#### **MEMORANDUM**

**Re:** 325 Main Street Google Signage Proposal

# 325 Main Street Google Exterior Signage

Exterior Penthouse Sign: 15'H Recessed Edge Lit Illuminated G Sign

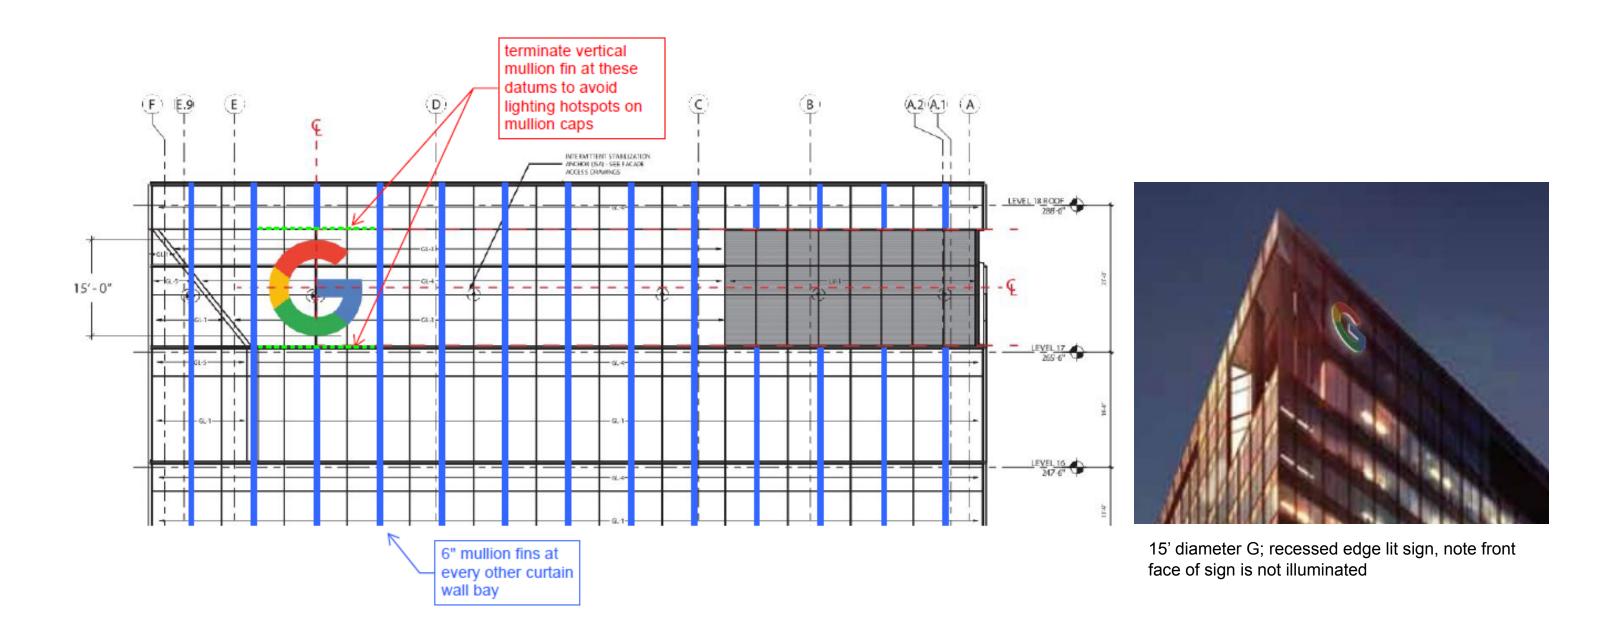
BXP provided the Committee with two options of the penthouse sign. Option one revealed a mullion through the center of the "G". Option two displayed the mullion completely removed in the location of the "G" sign. The Committee and Planning Board members recommended keeping the mullion as shown in option one, but agreed that eliminating the center portion of the mullion to create an interruption in the center of the sign presents an enhanced design.

## Penthouse "G" Sign – Light Studies

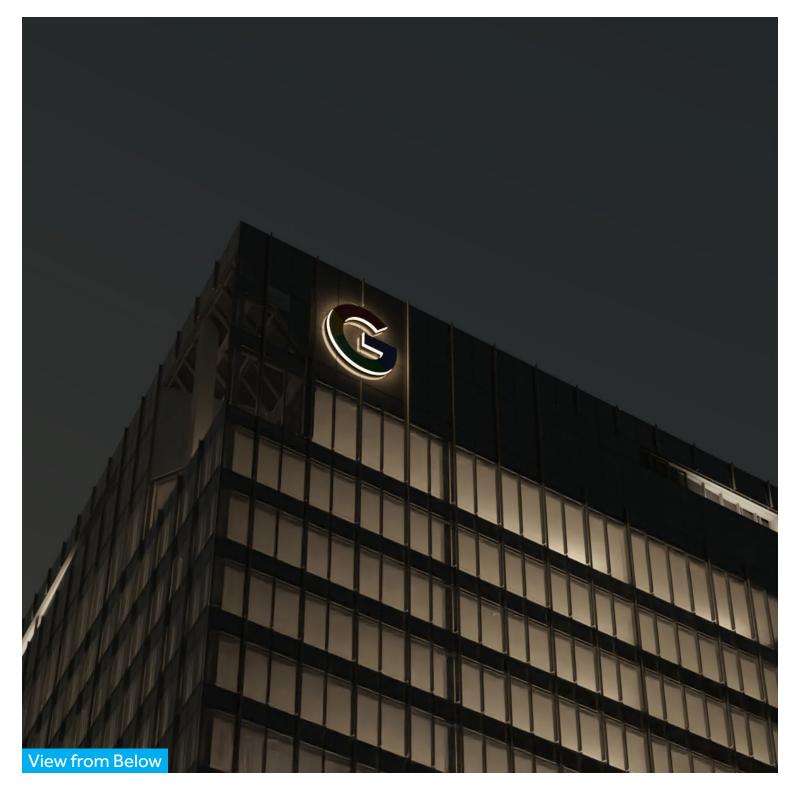
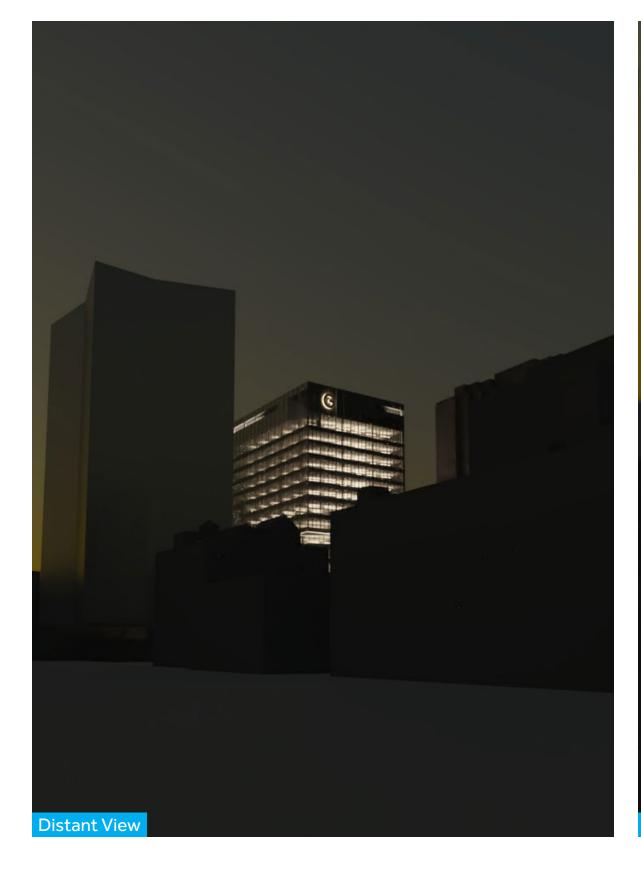
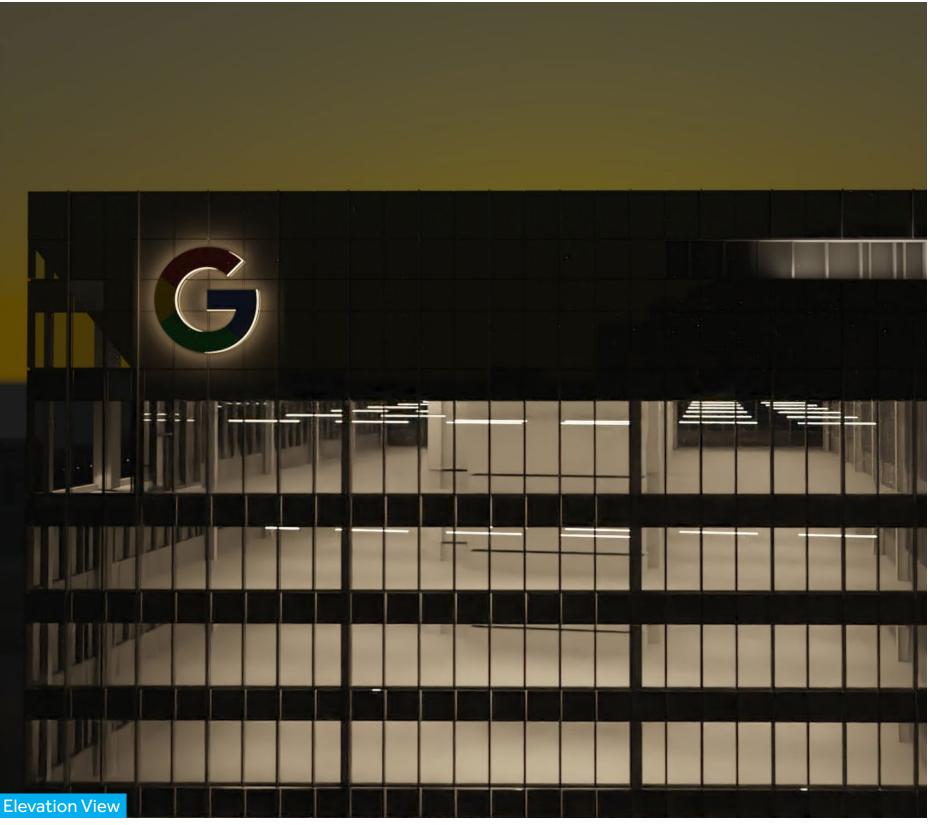
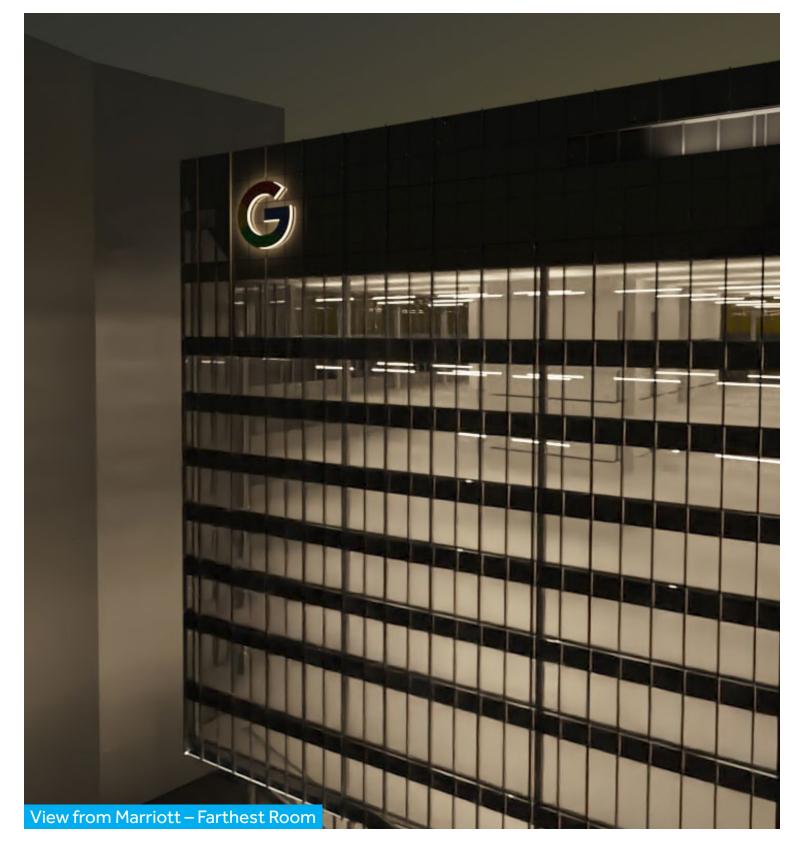
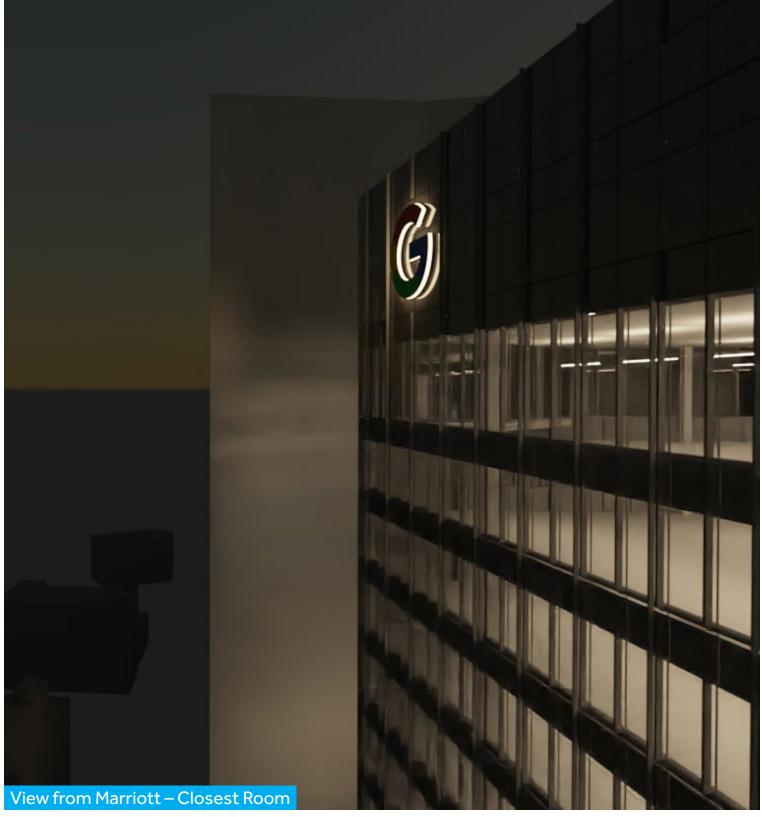
The Committee and BXP discussed an email delivered to the CRA by a resident of Kendall Square requesting requirement for the penthouse sign to be turned off after 10PM each evening. The Committee advised BXP to perform a night time lighting study and report back to the CRA on the hours that the buildings located in Kendall Square turn their lights off, to help inform the CRA Board's decision. BXP also suggested they could dim the sign during the nighttime hours.

#### ENTRY COLUMN SIGNAGE OPTION 1

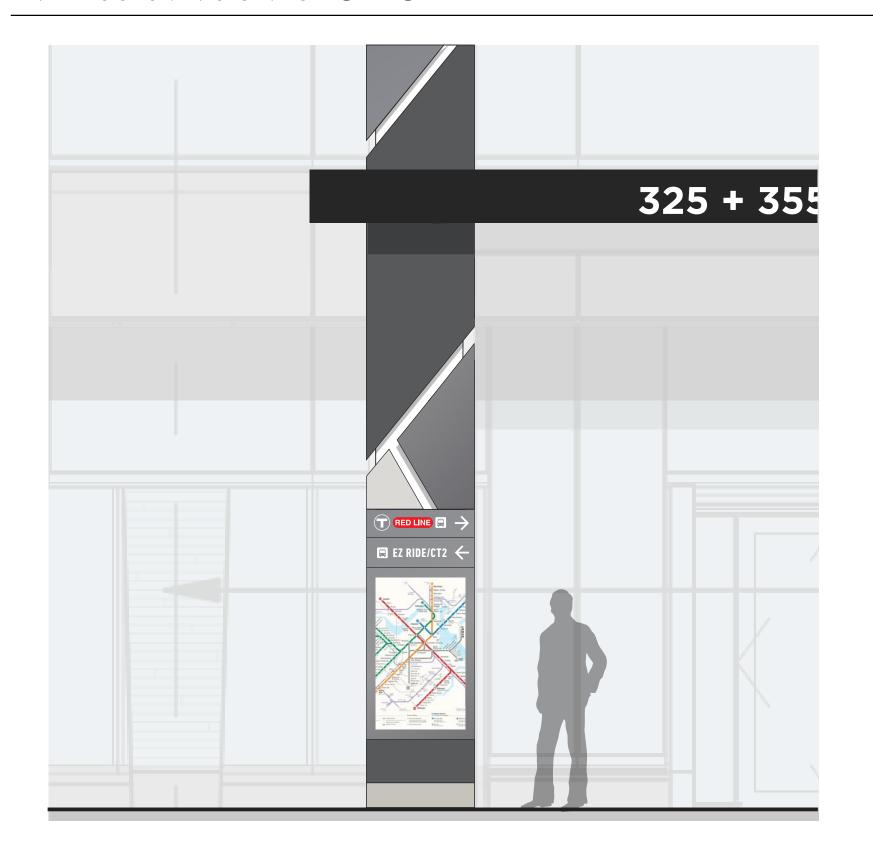
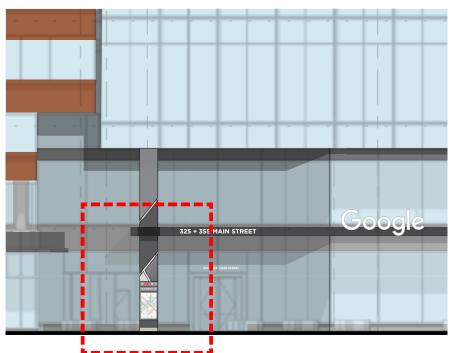
In the October 1<sup>st</sup> Committee meeting, the Committee suggested the addition of exterior street-level wayfinding signage. BXP presented options for a branded column that has the potential to include transit, community and other forms of informative material.

### Main Street "Google" Sign

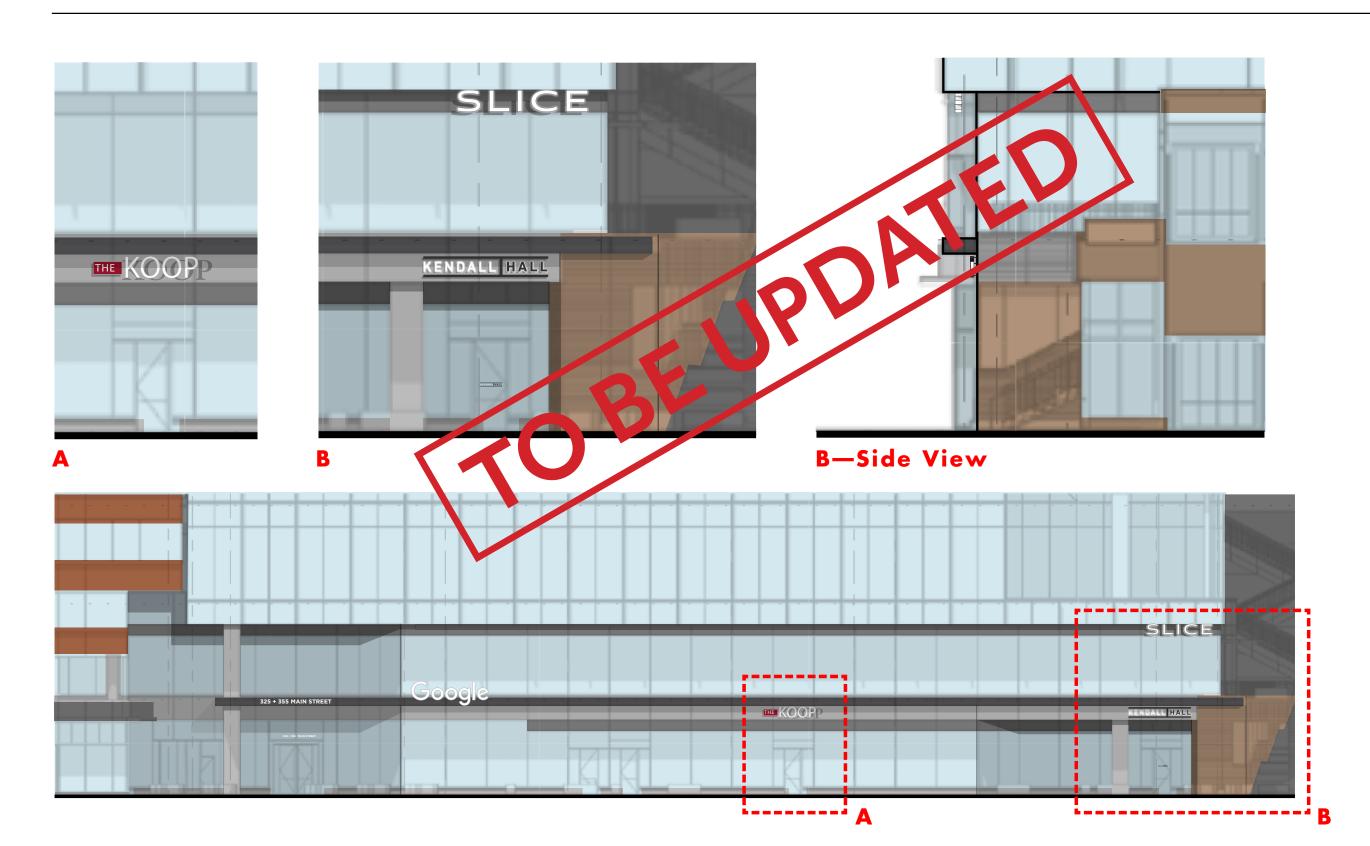
The Committee asked BXP to consider adding color to the "Google" sign similar to the penthouse sign. BXP expressed that they would articulate the sentiments of the Committee to their client.

# **Google Lobby Art Installation**

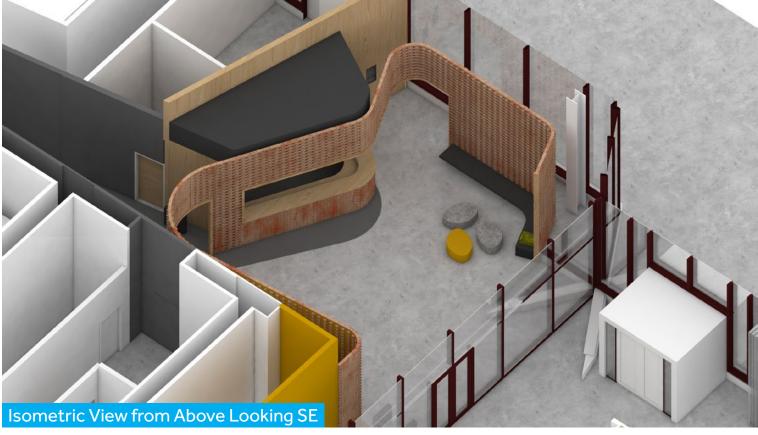
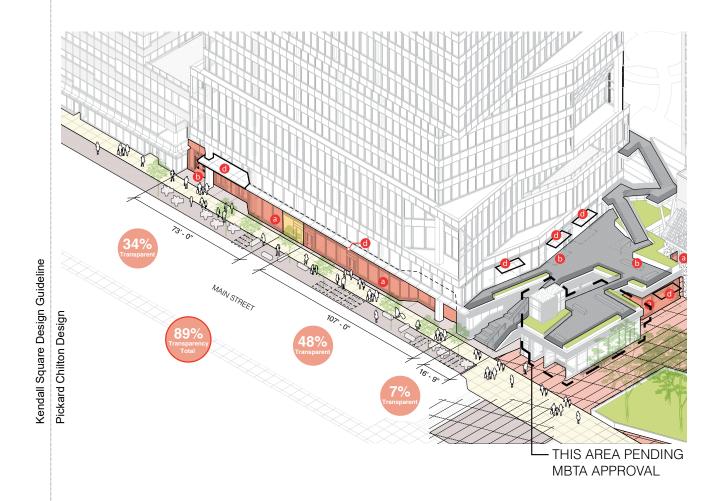
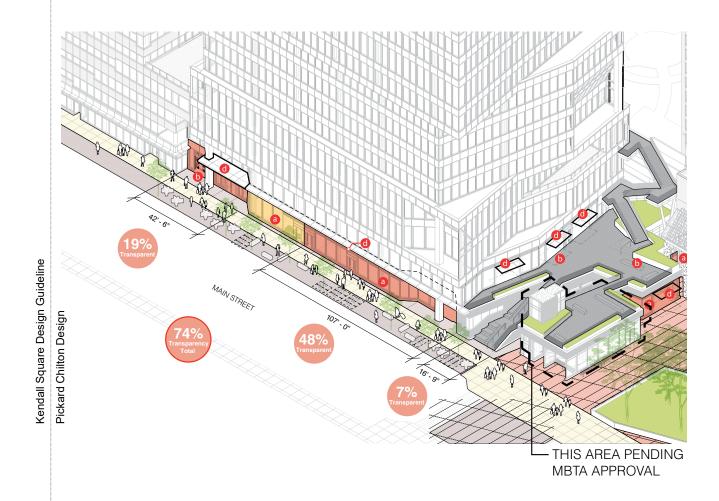
The final design element involves an animation of the interactive display wall located within the interior lobby area of the 325 Main Street lobby. The installation included LED tickers that are woven into the gaps created by the brick wall. The Committee expressed concerns with the lack of transparency the wall creates and asked that the design team examine options that creates more transparency. The Committee requested the design team provide the following items for evaluation to support their understanding of the interactive display wall:

- Samples of the bricks that will be used to create the wall
- Drawings or animation in plan view of the lobby
- Example of the brick wall with larger openings to reduce the barrier effect created by the initial design.

BXP has confirmed that they will work to enhance the design and report back to the CRA.
